RE: Flambeau Industrial Outlot Action Plan

RE: Amended Flambeau Industrial Outlot Action Plan

We have completed our review of the information contained in letters dated November 22, 2005 and December 2, 2005 regarding proposed excavation of gravel material in the Flambeau Industrial Outlot area. The proposed excavation work is a positive additional step in addressing the continuing issue of elevated copper concentrations in site runoff and the 0.9 – acre biofilter.

FLAMBEAU MINING COMPANY			
FIGURE 1			
OUTLOT ACTION PLAN			
Scale:		Date: NOVEMBER, 2005	
Prepared By:	Foth & Van Dyke	By: DAT	04F003

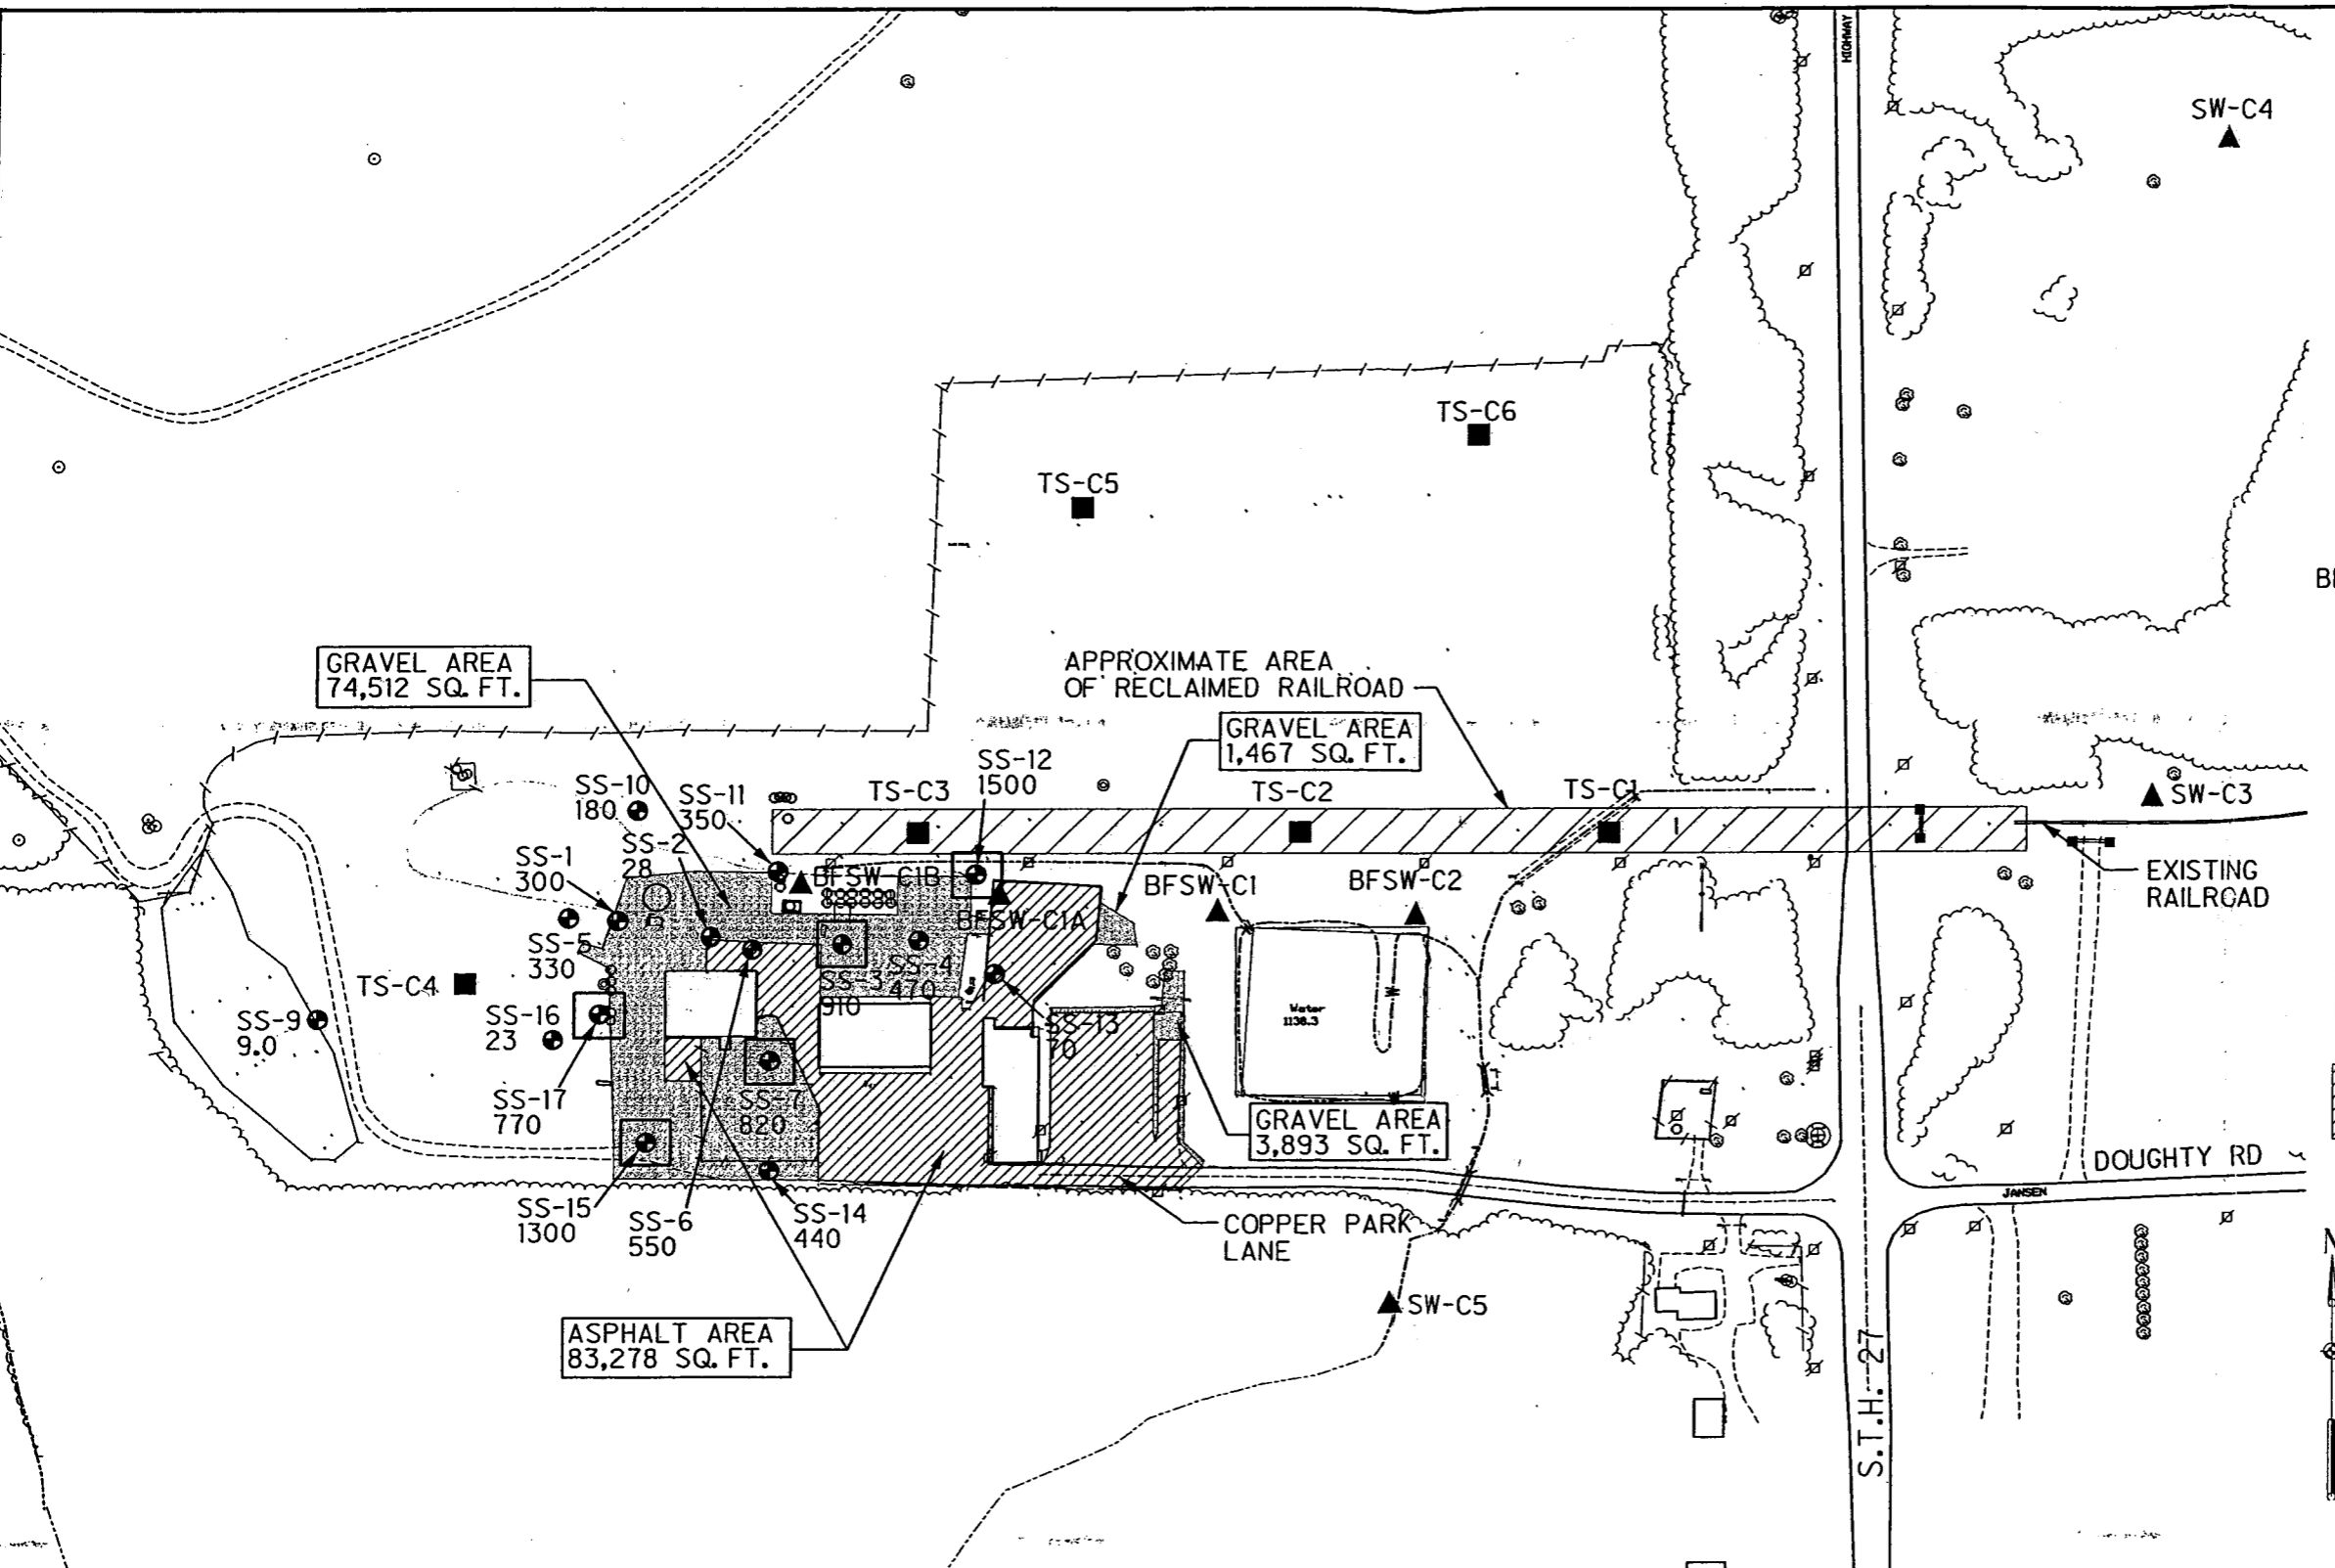
As part of an ongoing review of site conditions at the Outlot Area, surface soil samples were collected on August 9, 2005 to determine copper concentrations. The sample locations are shown on the attached Figure 1. The concentrations of copper in the soil samples varied from 23 mg/kg to 1500 mg/kg. It is likely that the copper levels in these surficial soils are contributing to the copper levels in the surface water runoff to the biofilter.

The gravel surface areas designated for action have been selected based on the soil sample test results for copper concentration. The area around sample locations with copper concentrations greater than 700 mg/kg will be excavated. A 50 foot by 50 foot area will be excavated to a minimum of 4 inches below the existing surface. The excavated soil will be disposed of off site at a licensed solid waste disposal landfill as a special waste. A geotextile will be placed on the bottom of the excavation then covered with a minimum of 4 inches of $\frac{3}{4}$ inch crushed limestone aggregate.

A total of five areas along with the ditch will be excavated. These five areas are centered on the following soils sample locations:

The drainage ditch between the Outlot buildings area and the reclaimed west rail spur area will be excavated and lined with the geotextile and covered with $\frac{3}{4}$ inch limestone aggregate (gravel). The entire run of the ditch from the west end of the Outlot Area near the water storage tank to the biofilter pond will be treated with this action

The original Action Plan called for excavating to a depth of four inches in five areas measuring 50 foot by 50 foot. Flambeau is amending the Action Plan to include excavating a minimum of four inches in all areas that are currently gravel around the buildings of the Industrial Outlot. The entire area of excavation around buildings and within drainage ways is approximately 10,500 square yards.

The procedures described in the two letters are generally acceptable. Please keep me and Ken Markart informed as to the schedule for initiation and completion of the work. Also, please provide a summary report of the work when the project has been completed and, if the work is temporarily halted due winter conditions, provide a status report of the work completed to that point and a description of the work to be finished in the spring.

In accordance with the November 22, 2005 Action Plan geotextile will be placed in the bottom of the excavation then covered with a minimum of four inches of ¾ inch crushed limestone aggregate. As feasible, Flambeau intends to conduct as much of the excavation and limestone fill before year end. Freezing ground conditions may defer the completion of the Action Plan until Spring 2006.
